AMD 01	AMENDMENT 1	06/22/2012
Revisions		Date

Drawing Title: PHASE 2 - WATER MAIN PLAN & PROFILE STA:5+00.00 TO STA:12+00.00

Project Title: VA MEDICAL CENTER REPLACE EXISTING WATER MAINS PROJECT

DRAWING NO. CU301

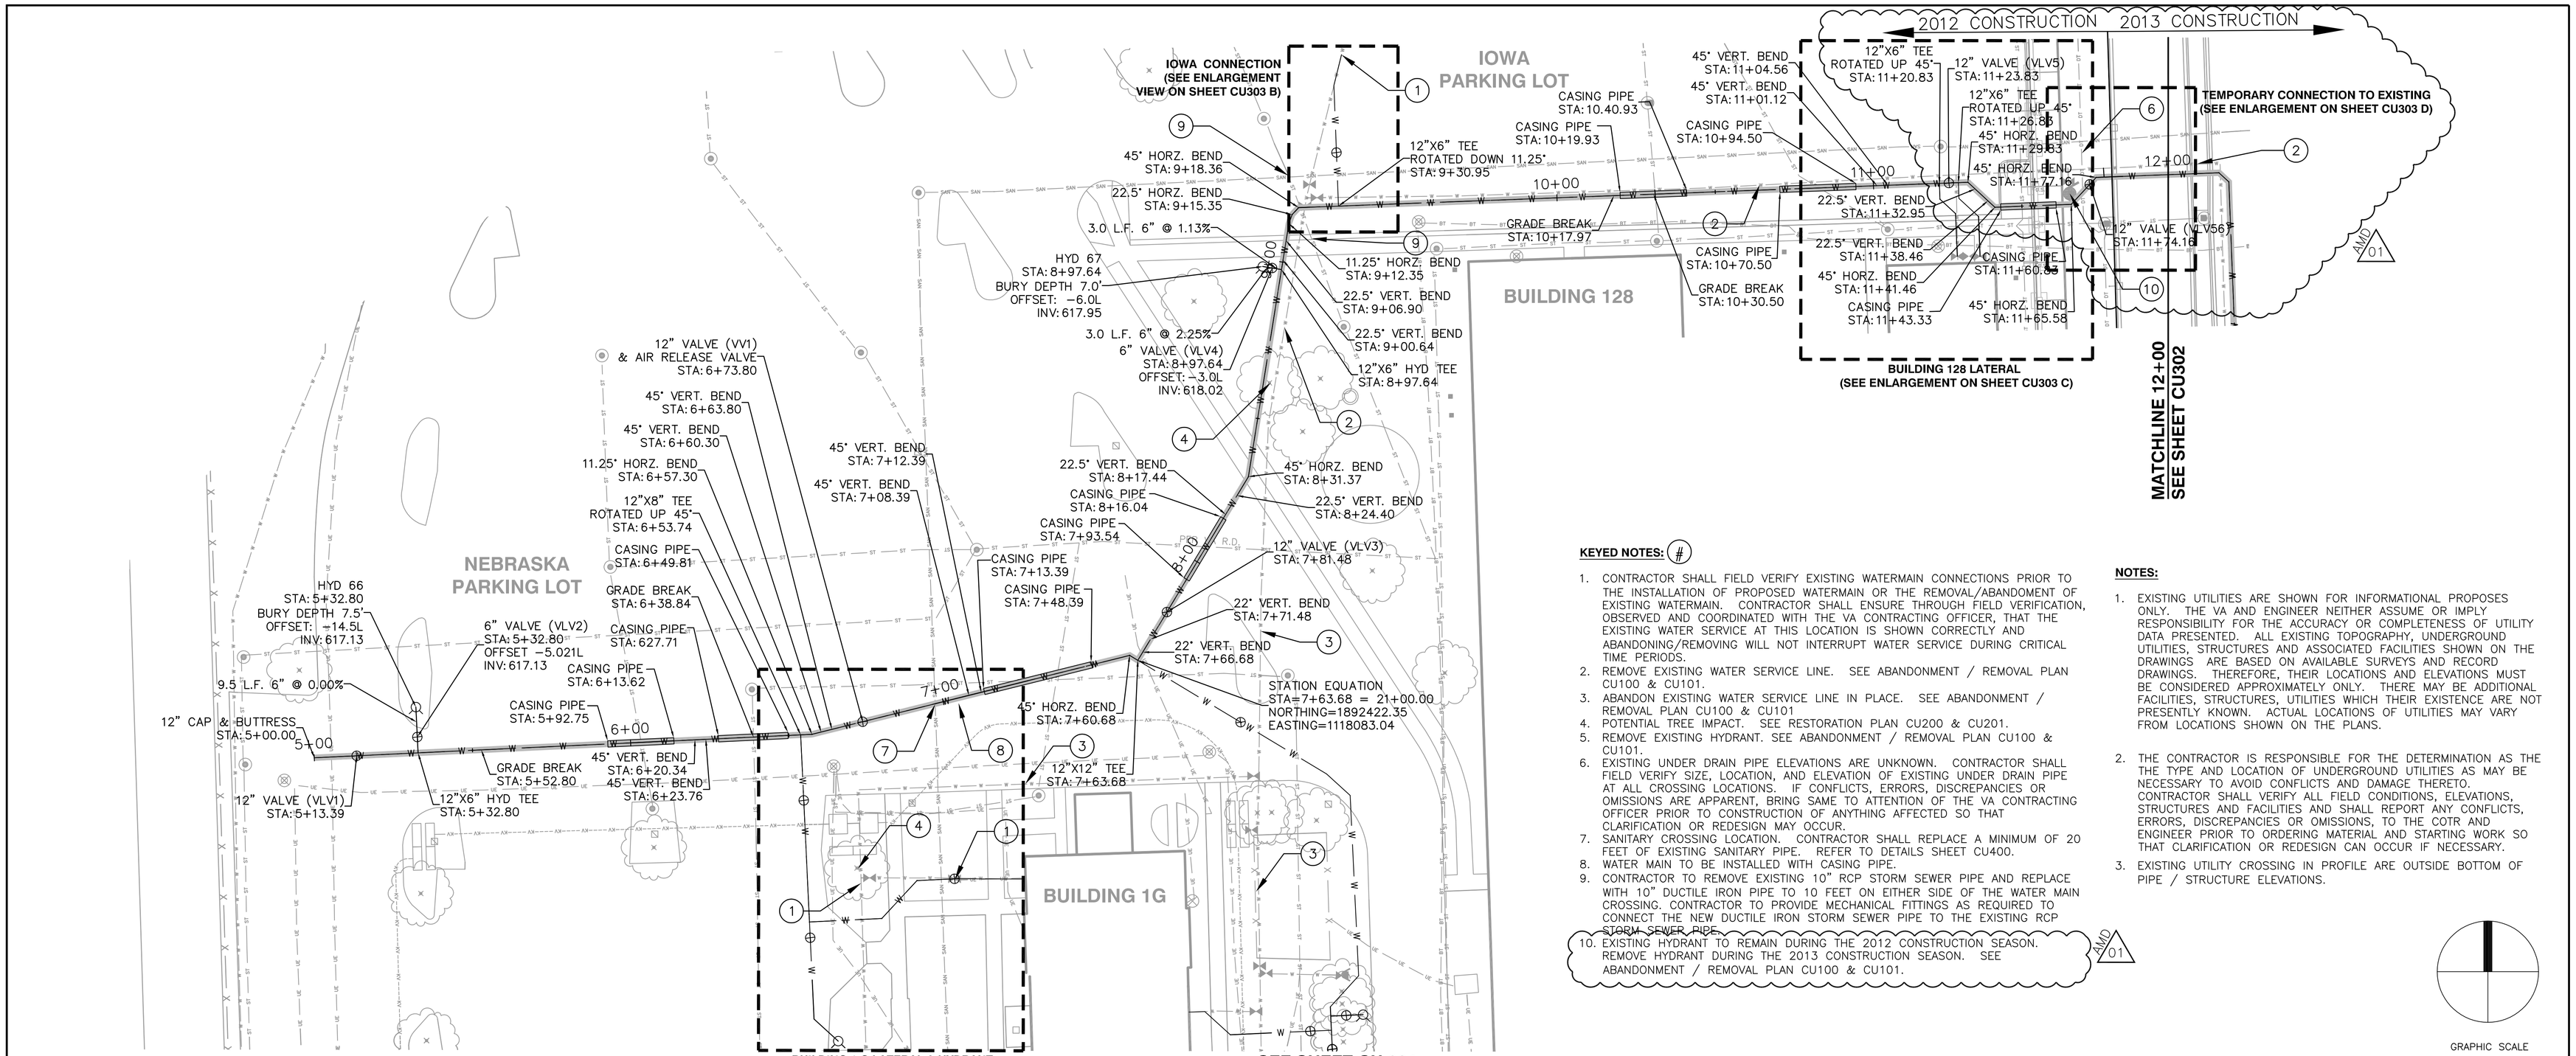
10. EXISTING HYDRANT TO REMAIN DURING THE 2012 CONSTRUCTION SEASON. REMOVE HYDRANT DURING THE 2013 CONSTRUCTION SEASON. SEE ABANDONMENT / REMOVAL PLAN CU100 & CU101. AMD 01
